Brocade Fabric OS v5.0.3a Release Notes v1.0

February 23, 2006

Documentation Updates

Figure 12-1 FICON CUP Management, Port Based Routing.

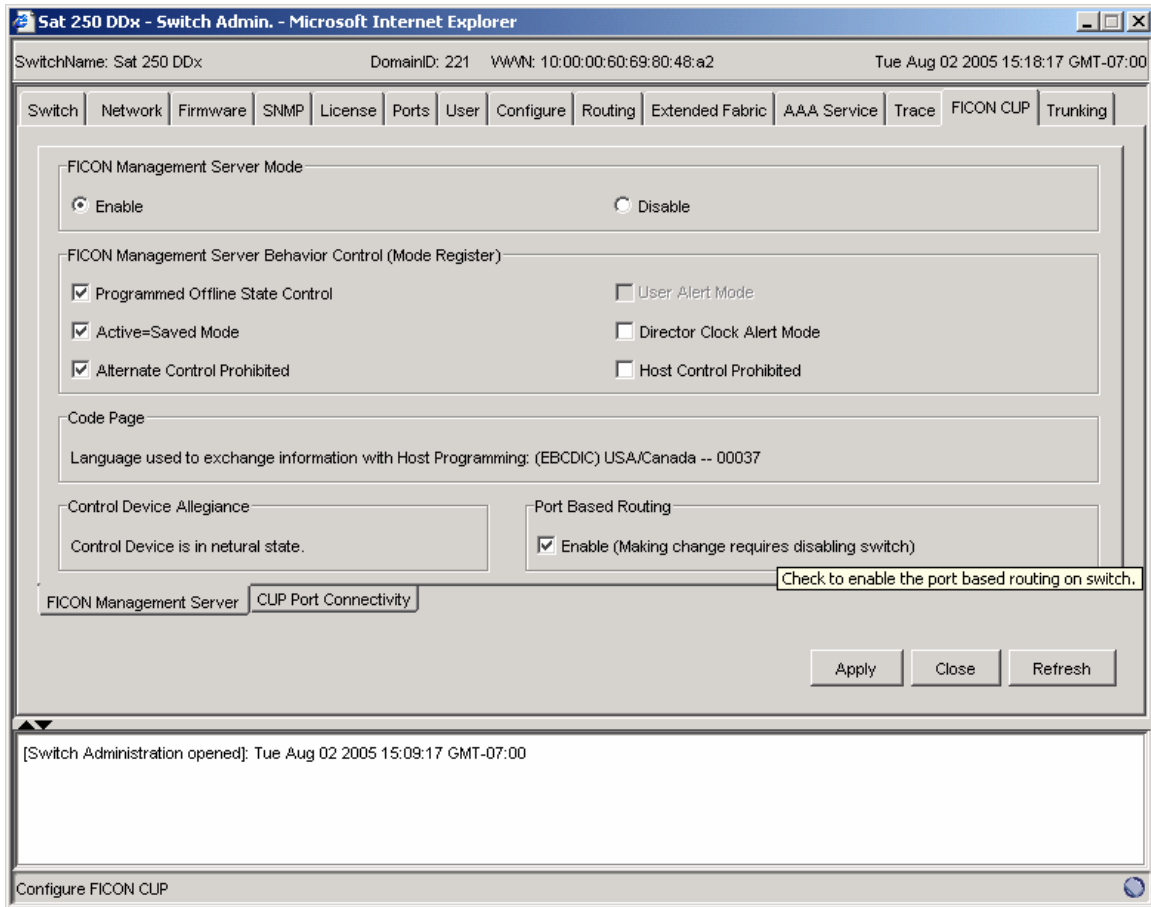
In Chapter 12, “Administering FICON CUP Fabrics,” on page 12-1, add a new section “Enabling Port Based Routing”

The FICON CUP tab displays, with the FICON Management Server subtab in front, as shown in Figure 12-1.

4. Click the **Enable** radio button to enable the port-based routing policy.

Figure 14-1 Accessing Performance Graphs

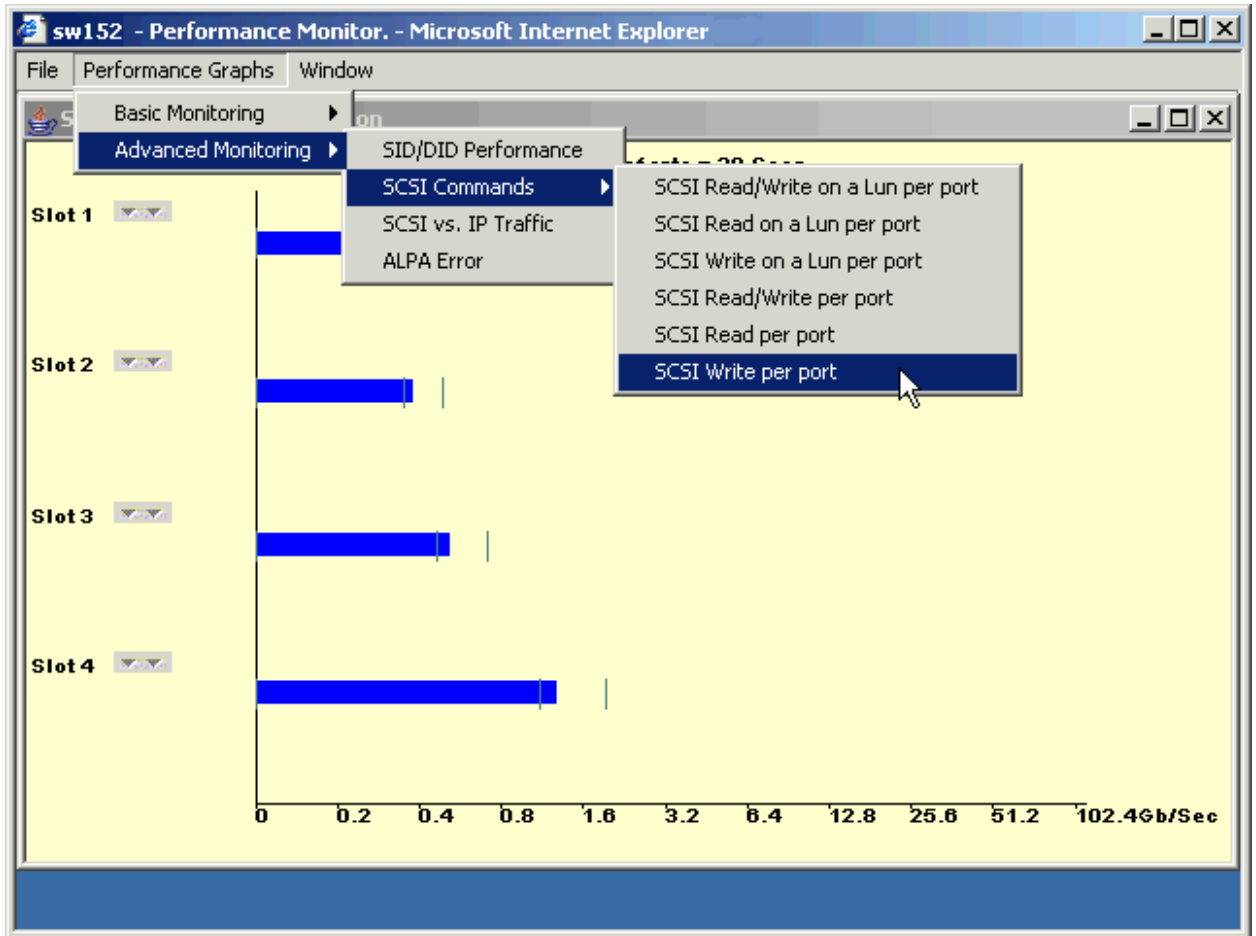
On page 14-3, replace Figure 14-1 with this one:
